STATE OF CONNECTICUT

Findings and Recommendations

Norwichtown Development, LLC. Request for an Interim Change to the Locational Guide Map Conservation and Development Policies Plan for Connecticut, 2005-2010

Proposed Interim Change Development, LLC Norwichtown

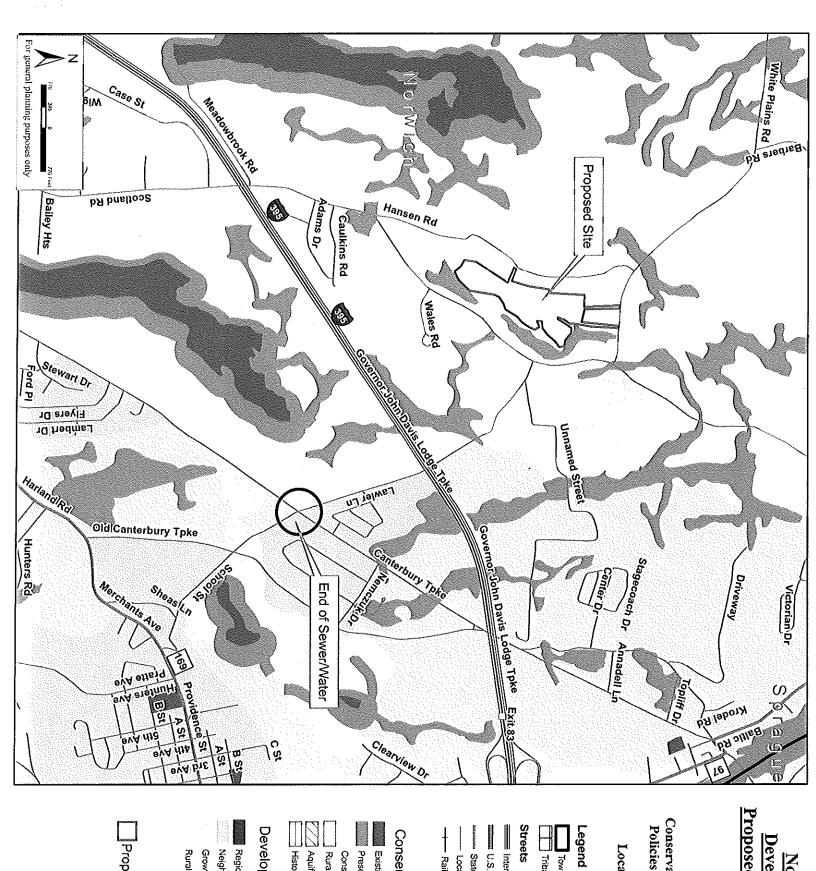
Norwichtown Development LLC., requests that the C&D Plan designation for a 59.9-acre parcel bounded by Scotland Road on the East, and Hansen Road to the West, be changed from "Rural" to "Neighborhood Conservation" (see attached maps). In accordance with state regulations, the City of Norwich was afforded the opportunity to request a joint public hearing with OPM and the Continuing Committee regarding this application. The City opted to waive its right to a public hearing.

OPM recommends that the Continuing Committee not approve Norwichtown Development's request to change the sites' C&D designation from "Rural" to "Neighborhood Conservation." In order to provide this site with access to public water and sewer, it would require the extension of public water and sewer approximately 5,000 feet. Nearly 2,500 feet of this would go through areas designated as Rural and Conservation areas, which are not addressed in this application, before reaching the subject property. OPM's concern is that such an extension would facilitate further intensive development in these areas that are not subject to a change under this

application. In doing so, the potential exists for further requests for changes to the C&D Plan's Locational Guidemap requiring the action of OPM and the Continuing Committee.

In addition to potential impacts on other areas, OPM questions the necessity for the change at this time. The applicant indicates that the City's zoning regulations require that Active Adult Communities be connected to public water and sewer. However, Section 7.6.4(h) of the Norwich zoning ordinance states:

OPM is not aware if the applicant has investigated the potential of on-site alternatives for water and sewer in this area such as a community septic system or alternative treatment technologies. The use of such technologies, when constructed properly, can provide for the type of development density the applicant seeks. Such alternatives could negate the need to extend public utilities to the subject parcel, yet still accommodate cluster type or "Conservation Development" techniques that are supported in the C&D Plan for Rural Lands.

The City of Norwich has waived its right to a public hearing with regard to this application. As a result, OPM must make this recommendation based solely on the information presented by the applicant. OPM is not aware of any previous approvals issued at the local level, including a willingness or capacity to service this area with public water and sewer. Further OPM is not aware of any measures that may be in place to limit development densities that may be achieved in the additional areas not subject to this application, through the introduction of this infrastructure. Similarly, OPM is not aware of any provisions for open space preservation or "Conservation Development" techniques that may be planned on site. The City's plan of conservation development does encourage development of elderly housing yet also encourages the maintenance of low-density development within this particular area (known as the "Plain Hill" area). Additionally, the plan suggests that subdivision design should be done in accordance with the natural carrying capacity of the land, which is consistent with the current designation of Rural Lands.

In light of these issues, OPM recommends that this area remain designated as Rural Lands. There are significant areas in Norwich designated for growth where the use of state funding for infrastructure and development of this nature would be more appropriate. Neighborhood Conservation areas are typically already developed, dense residential areas with existing infrastructure. Generally, state policy for these areas is to promote infill development where the infrastructure to support it exists. Considering the low-density zoning of the area, OPM believes a change from Rural to Neighborhood Conservation would not be appropriate for this area.
